**BID IDENTIFIER: MCOE E-Rate Year 2024 RFP Bid # 2024-07**

**BID PACKAGE TITLE: MERCED COUNTY OFFICE OF EDUCATION (MCOE) E-RATE YEAR 2024 REQUEST FOR PROPOSAL**

**ADDENDUM DESCRIPTION: MCOE E-Rate Year 2024 RFP Bid # 2024-07 – Response to Questions**

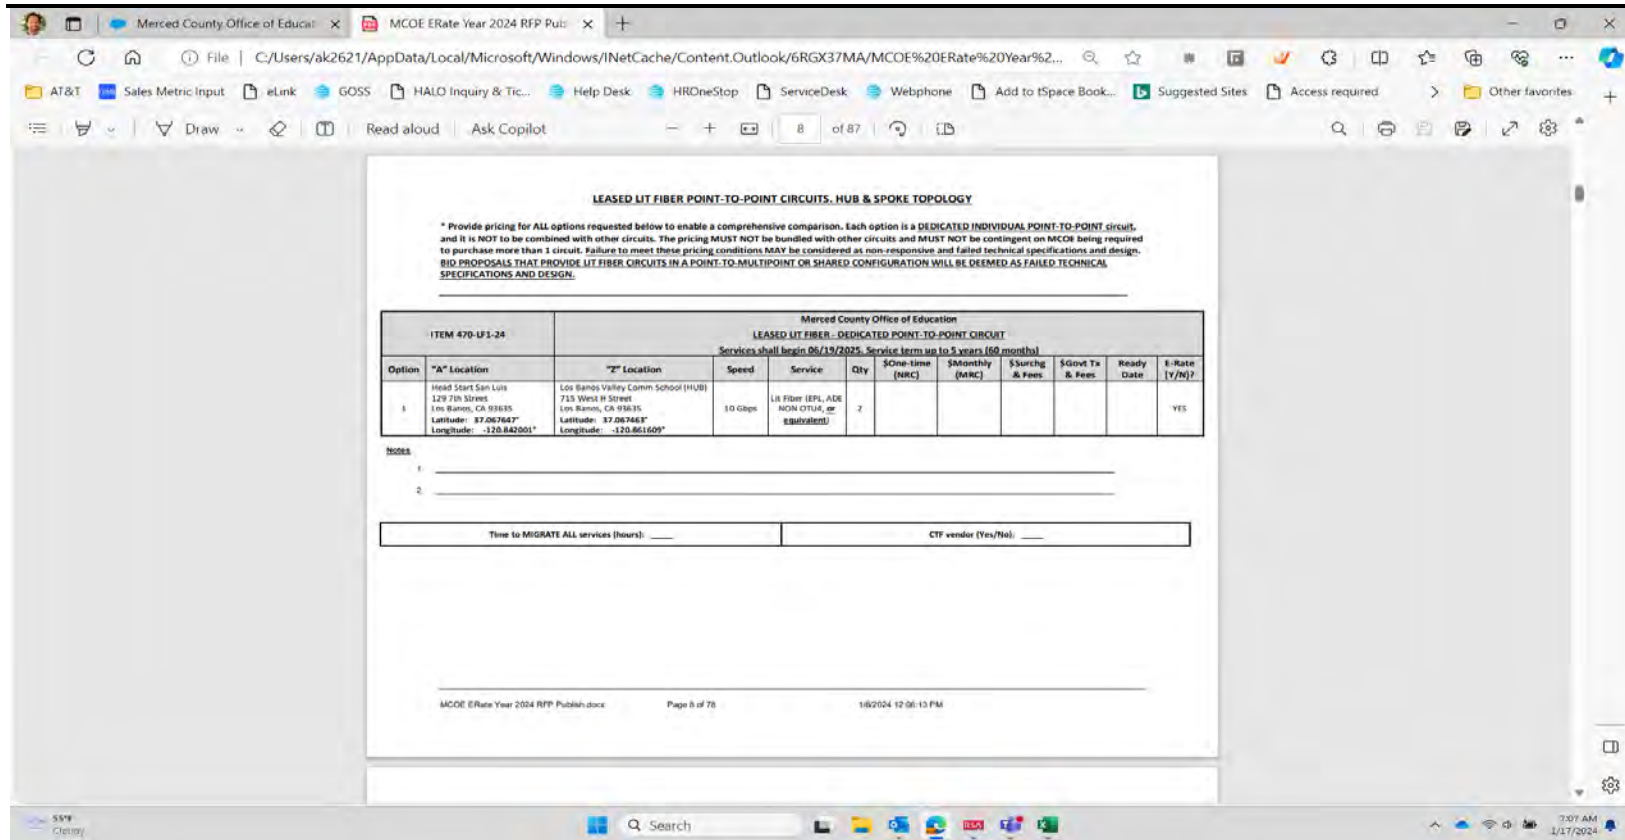
1. AT&T requires clarification on the following (Screen Shot below)

For the Leased Lit Fiber Point to Point circuits. Question applies to All A&Z in RFP. The Quantity shows for each pair of locations shows speed 10G and quantity (2), however please clarify the request:

- a. Are you simply asking for 2 identical 10G PTP circuits with the same A & Z locations. (Effectively 20Gbps of bandwidth between the 2 sites) Which would take a common physical route from Loc A to Serving AT&T Central(s) office and then common physical route to Loc Z.

- b. Are you asking for 2 disparate (Diverse Physical entrance, diverse local loop route, diverse serving AT&T central office) 10G Circuits with the same A&Z locations.

- c. Perhaps something else entirely?

Answer: Yes. We are asking for 2 identical 10G PTP circuits with the same A & Z locations (effectively 20Gbps of bandwidth between the 2 sites) which would take a common physical route from Loc A to Serving AT&T Central(s) office and then common physical route to Loc Z.

Answer: No, we are NOT asking for 2 disparate (Diverse Physical entrance, diverse local loop route, diverse serving AT&T central office) 10G Circuits with the same A&Z locations.

Answer: No. As stated in the response to Question 1a, we are asking for 2 identical 10G PTP circuits with the same A & Z locations (effectively 20Gbps of bandwidth between the 2 sites) which would take a common physical route from Loc A to Serving AT&T Central(s) office and then common physical route to Loc Z.
